Project SVM
Docket 70-36

Subject: Mallinckrodt Chemical Works

We have reviewed the October 31, 1958
and the additional information submitted on November 14,
request of Mallinckrodt Chemical
Works, for AEC approval of two shipping
containers.

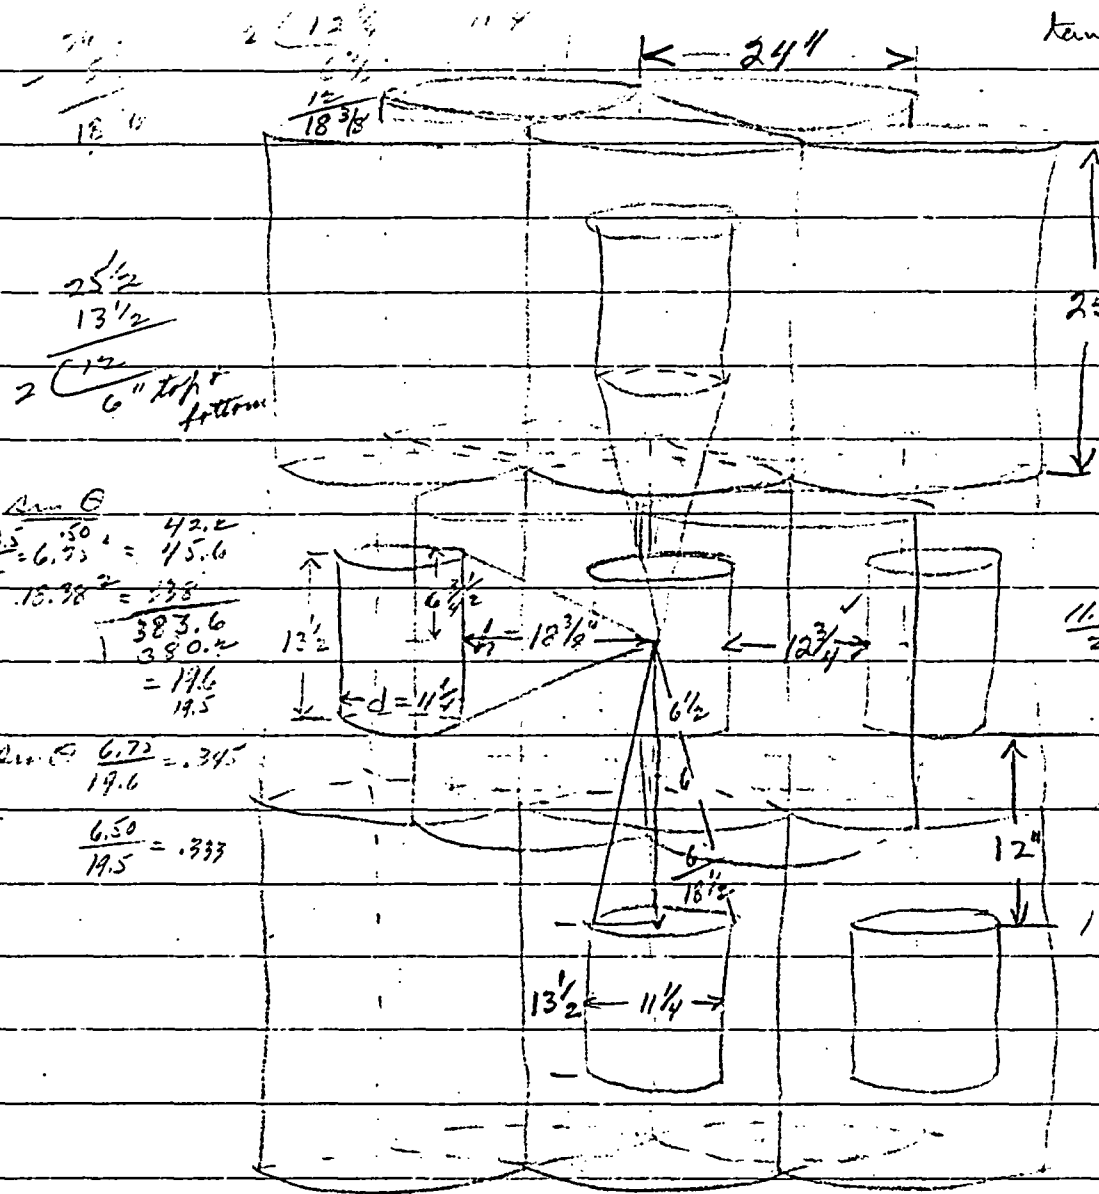
General: $\frac{\text{Cross sect area}}{\text{Sep. Dist}^2} = \frac{11.25 \times 13.50}{18.37^2} = 0.45$ for one drum

for 6 drums, $\Omega = 6 \times 0.45 = 2.70$
vs. 2.45

End to End $\frac{.785(11.25)^2}{18.5^2} = .29$

2 drums $\Omega = 2 \times .29 = 0.58$ vs 0.55

For 6 replace drums $\Omega = 6 \left[2 \frac{d^2}{12h} \frac{1}{h} \sin \theta \right] = 12 \frac{11.25}{18.38} (.333)$
Using relation $\frac{\text{Cross Sect. Area}}{(\text{Sep. Dist})^2} = \frac{13.5 \times 11.25}{(18.38)^2} = 0.45$
 $6 \times 0.45 = 2.70$

for drums above and below $\Omega = 2 \left[2\pi (1 - \cos \theta) \right] = 2(6.29)(1 - .956)$
 $\frac{.785(11.25)^2}{(18.5)^2} = .29$, $.29 \times 2 = .58$

Total angle = $2.45 + 0.55 = 3.00$

$\frac{3}{12.7} = 23.9\%$ OR if $k=0.58$ Single layer $\rightarrow 2.45/10 = 24.5\%$ $k=0.65$
Var 8% for $k=0.8$
